NUMBER: 82-1

DATE: 1/22/82

- A. Power Trim Cylinder Repair Tool - P/N 91-89671A1
- B. Fuel Filter "O" Ring - P/N 25-98277
- C. Carburetor Fittings - Fuel Enrichener
- D. Cowl Removal - 1982 V200
- E. Torque - Merc 40/50/70 Gear Housing Cover Nut

**Figure 2. Enrichener Fittings**

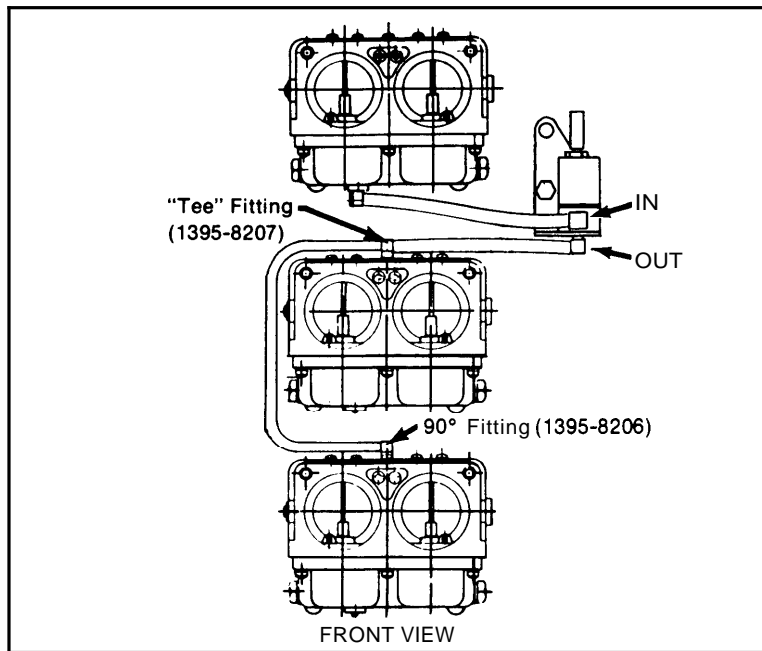
The "T" fitting and 90° elbow carburetor fuel line connectors (Figure 2) used on those outboards equipped with the fuel enricheners are now in service replacement stock. Order Part Numbers:

1395-8206

90° Fitting

1395-8207

"T" Fitting

**Figure 3. Releasing Cowl Latch**

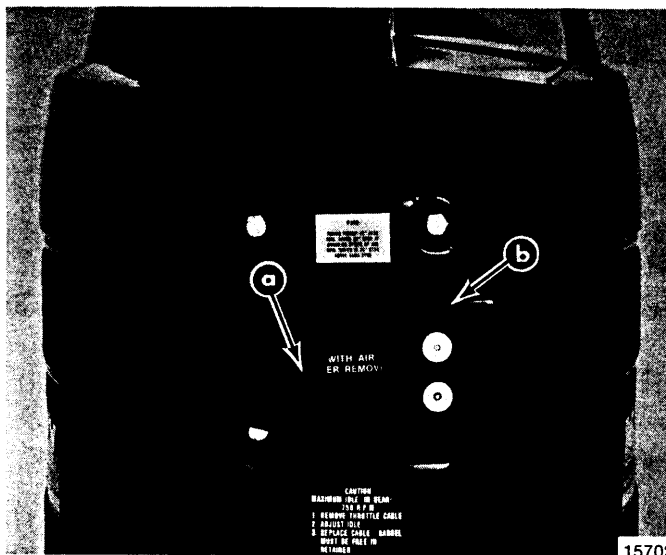
The 1982 V200 Outboard has a safety catch on the cowl latch which makes it difficult to release the cowls when the outboard is on the shipping skid. After removal of the front cowl (DO NOT cut the band around the drive shaft housing until after the lift ring and engine hoist have been installed) it may be necessary to release cowl latch with a rod or large screwdriver. Reach under powerhead and release the cowl latch (Figure 3) and remove the cowls. Then install lifting eye and engine hoist, cut band from drive shaft housing and carefully lift outboard away from shipping skid.

a - Inner Cowl Latch (Push in where shown)

b - Outer Cowl Latch
